ENVIRONMENTAL ASSESSMENT REPORT APPROVAL MODIFICATION NO.3

Barangaroo Headland Park and Northern Cove

Document Number: RPT-MOD3-001[4]

Barangaroo Headland Park and Northern Cove – Main Works
10_0048 Modification No.3

BARANGAROO HEADLAND PARK - CARPARK COMPARISON

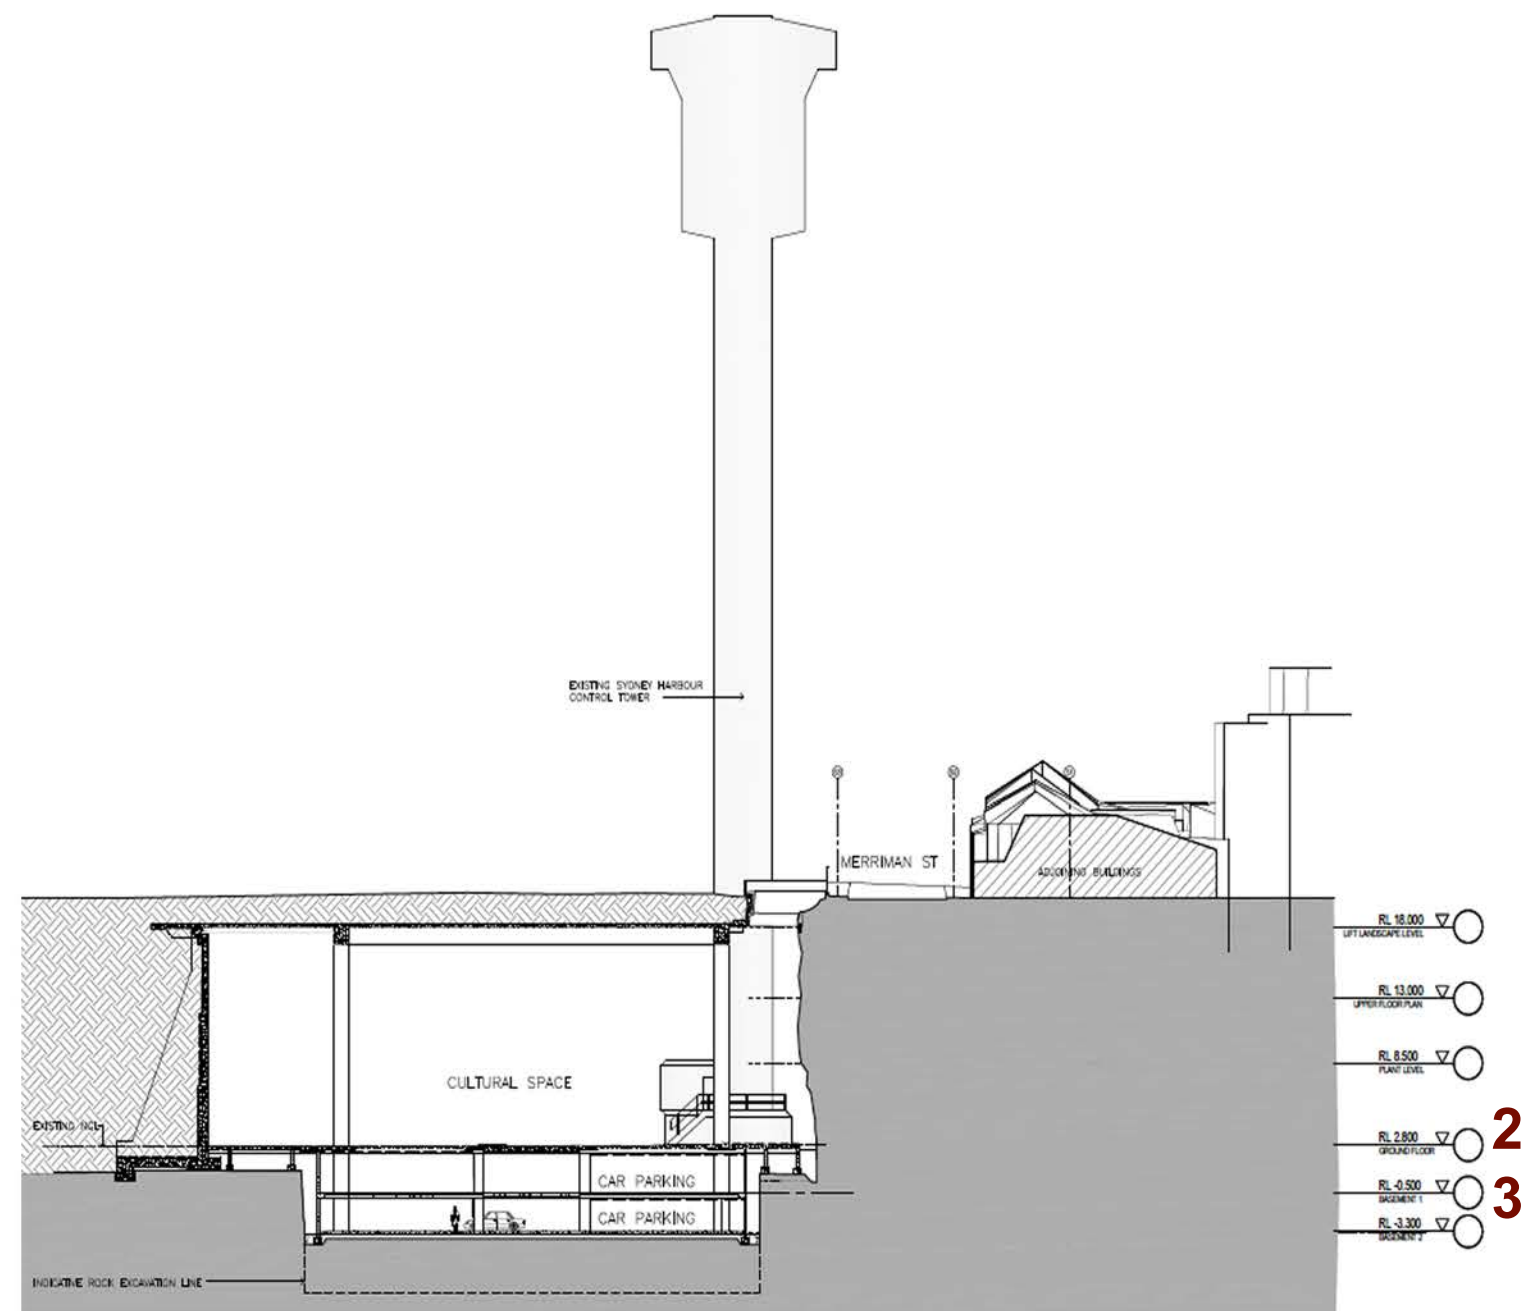
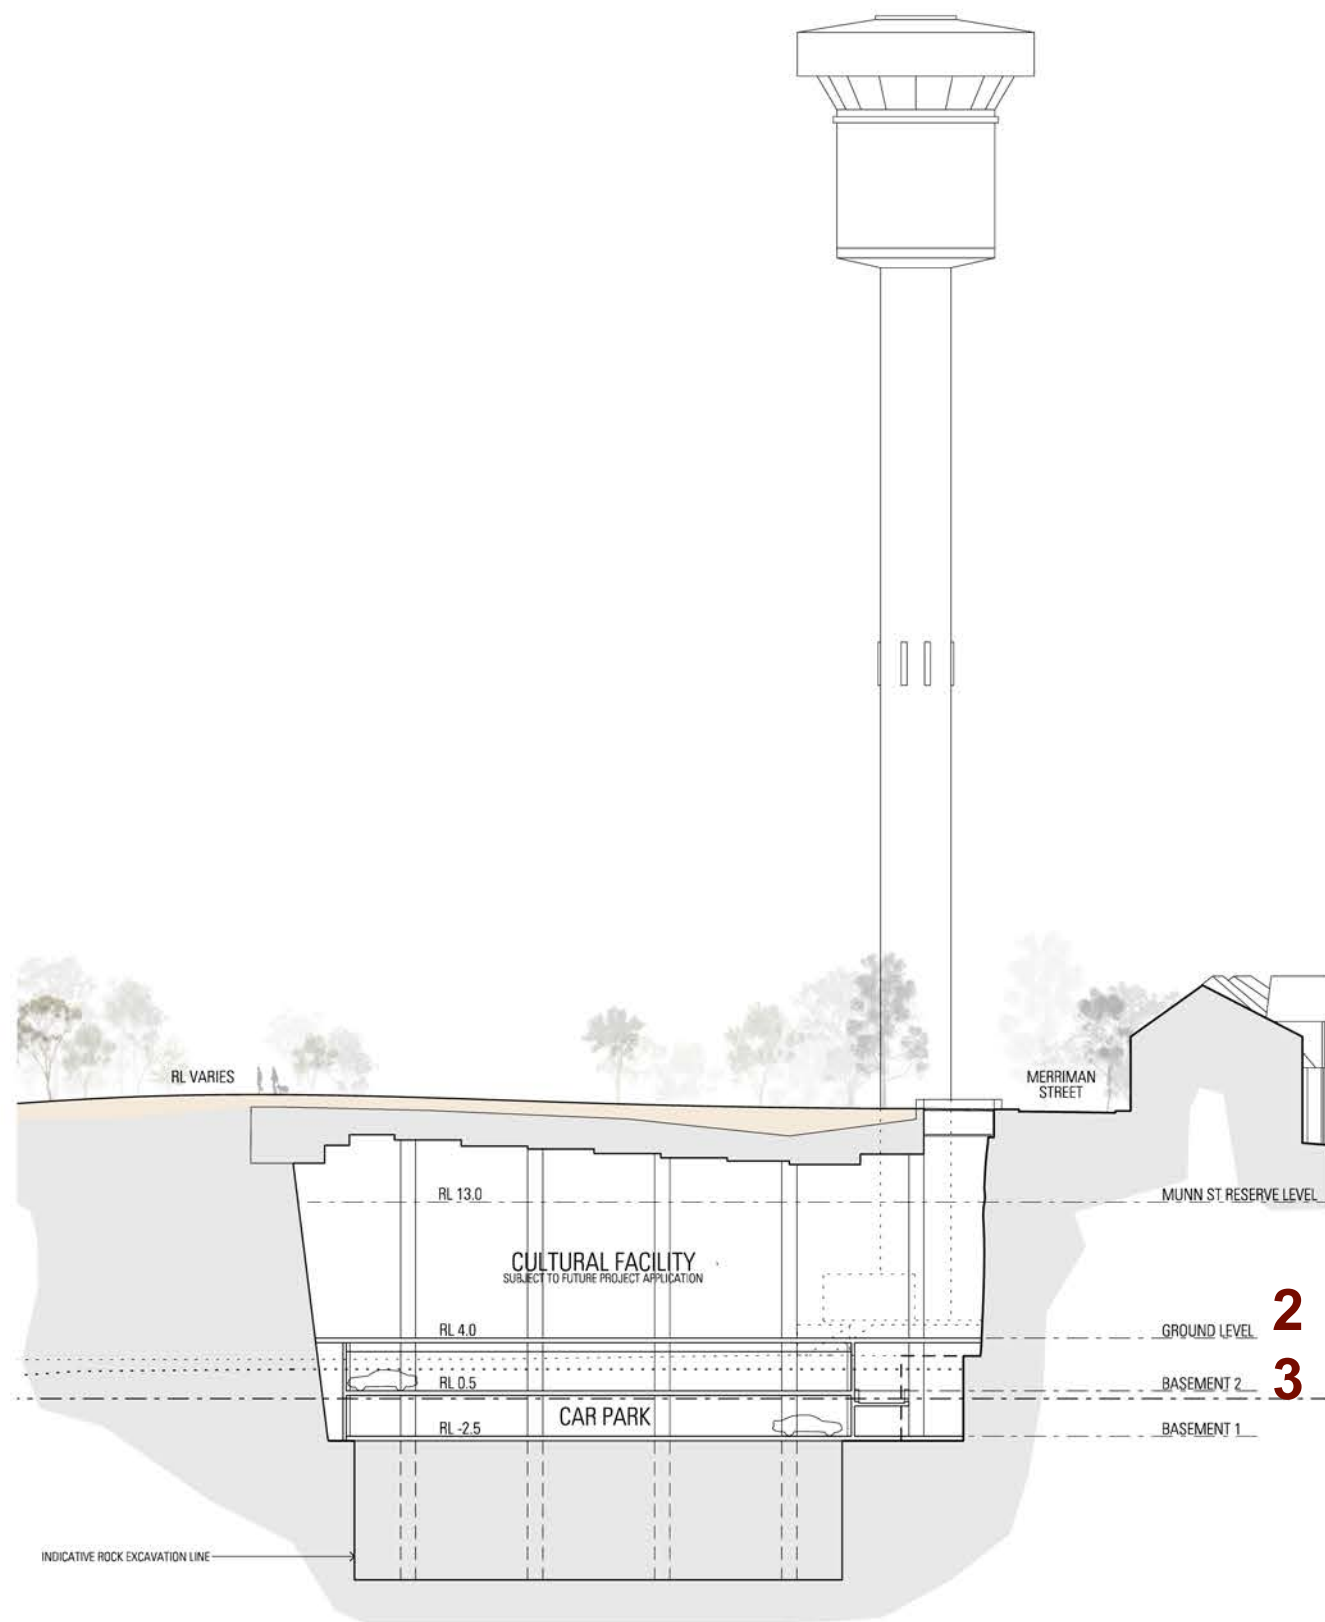
Refer to Table 2-1
3 Changes to the car park

2 Change to cultural space ground level

3 change to car park levels

Project Number
12020
Drawing Number
CO-JPW-L-S3-0100

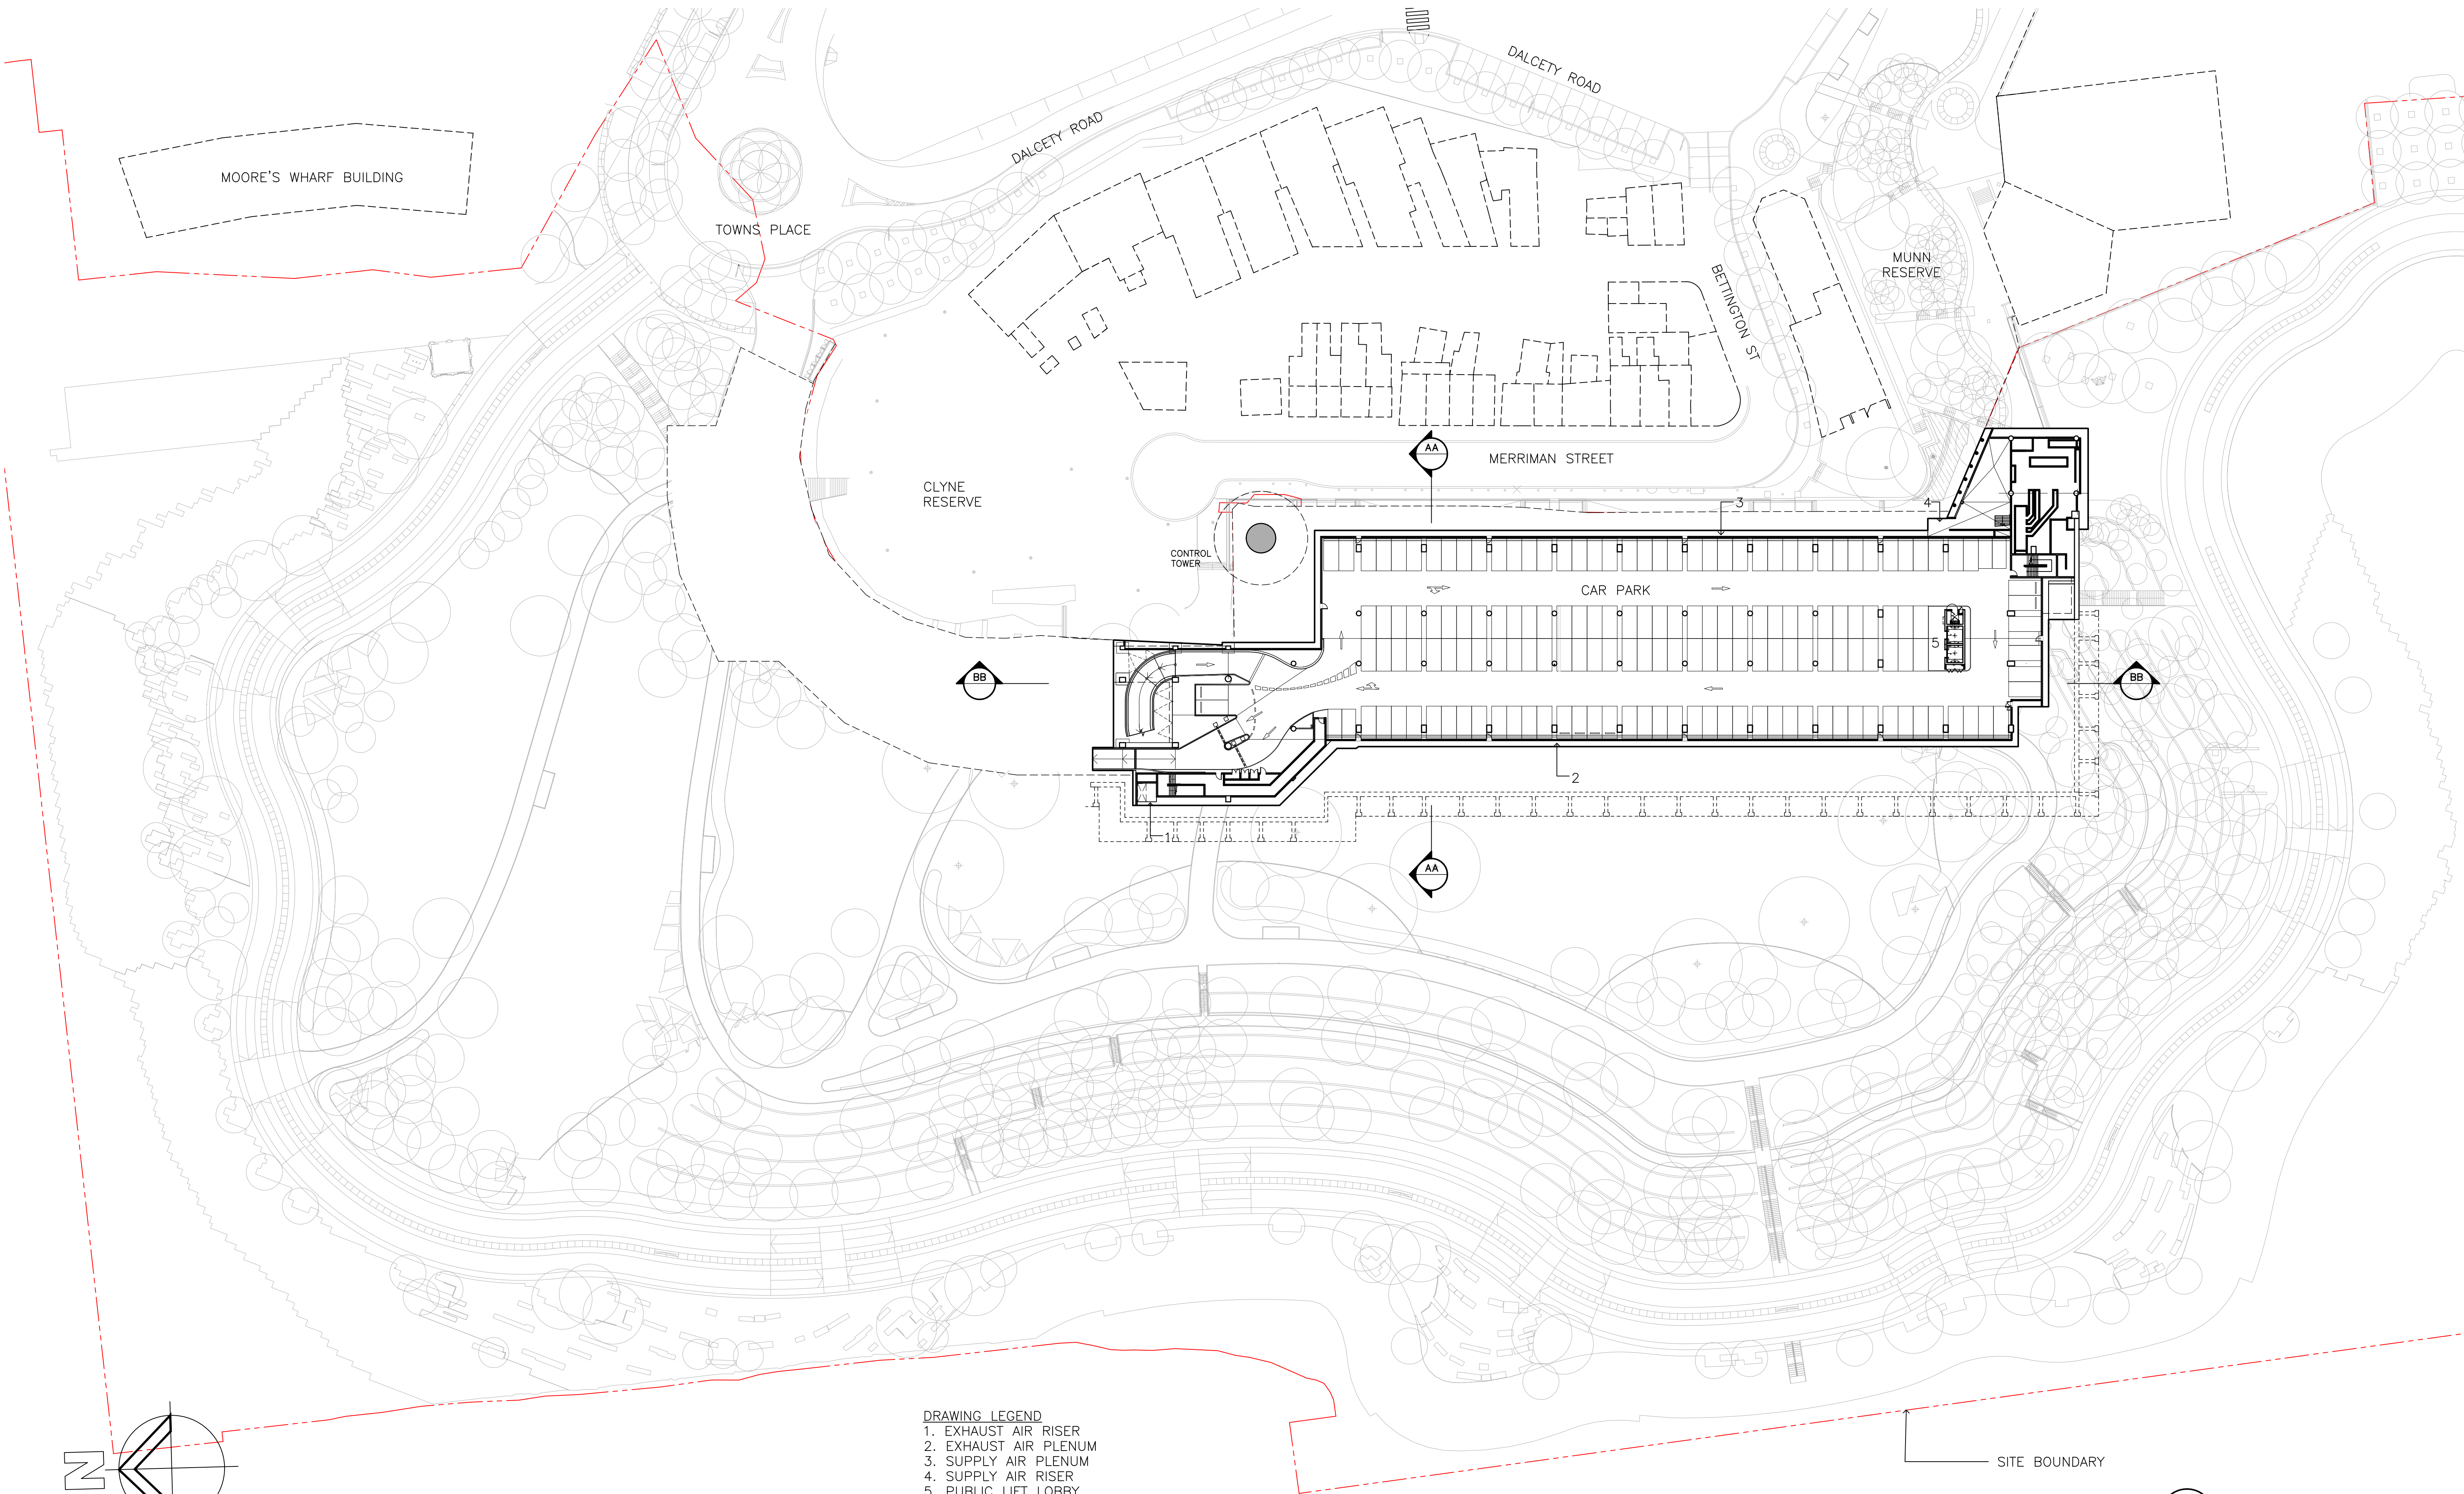
The revised landscape design (drawing CO-JPW-L-S3-0100) for the Project is included in Appendix B. The drawing shows finished levels and demonstrates that the Project, inclusive of the proposed changes would not materially change finished levels. In relation to the matters raised by DGR No.4, the following is specifically noted:

- Finished levels on the eastern edge of the Headland Park are not altered by the proposed changes.
- Views over the Headland Park are not materially altered and are not obstructed by the proposed changes. At the Merriman Street interface, the proposed palisade fence and a lower balustrade fence on the park side, is designed as open metal construction that will allow for a visual sense of the park on the Merriman Street side of the skylights, allowing for park plantings to be the dominant feature as viewed from Merriman Street. The generous park planting at each pedestrian entrance will come right up to the palisade fence creating the sense of park at Merriman Street, and breaking up the length of skylights opening up to the cultural space below.
